AMD-K6[®]

Processor Revision Guide

Model 6

| Publication # 21266 Rev: G Amendment/0 Issue Date: August 1998 |

Figure 1. AMD-K6[®] Processor Assertion of HLDA Due to Simultaneous BOFF#/HOLD Assertion

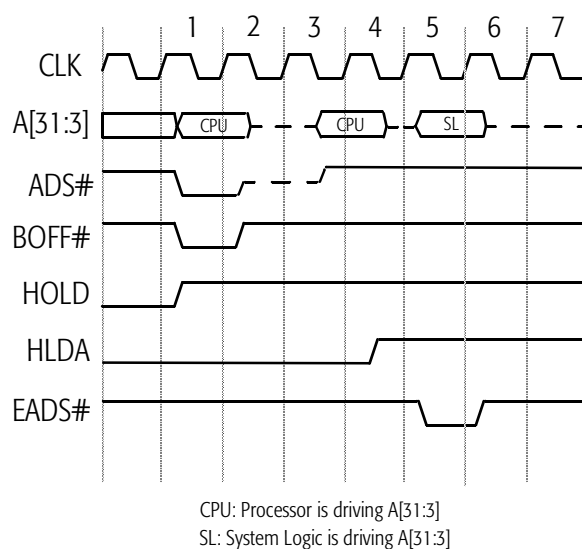
Non-conformance. If BOFF# and HOLD are sampled asserted on the same clock edge that negates ADS#, the processor asserts HLDA two clock edges after HOLD is sampled asserted.

Potential Effect on System. There are three potential effects of this erratum to consider:

- If the system logic asserts BOFF# for a duration of one clock, anticipates the assertion of HLDA in clock 3 (see Figure 1)—which is the normal specified operation—and drives the address bus and EADS# for an inquire cycle in clock 3, then the processor will not sample EADS# asserted. In addition, address bus contention will occur in clock 3.

- If the system logic asserts BOFF# for a duration of two clocks, anticipates the assertion of HLDA in clock 3, and drives the address bus and EADS# for an inquire cycle in clock 3, then the processor will not sample EADS# asserted. (No address bus contention occurs in this case.)

- If the system logic asserts BOFF# for a duration of one clock, anticipates the assertion of HLDA in clock 3, and drives the address bus and EADS# for an inquire cycle in clock 4, then address bus contention may occur in clock 4. (The processor will sample EADS# asserted in this case.)

If the processor does not sample EADS# asserted during an inquire cycle, cache/memory incoherency will occur. Address bus contention can affect the reliability of the processor and the system logic.

Suggested Workaround. The system logic must sample the assertion of HLDA before asserting EADS# and driving the address bus for an inquire cycle—as shown in clock 5 of Figure 1.

Resolution Status. AMD has determined that all Socket7 and Super7[™] chipsets operate as described in the aforementioned suggested workaround. Therefore, AMD has decided to defer the resolution of this erratum until deemed necessary.
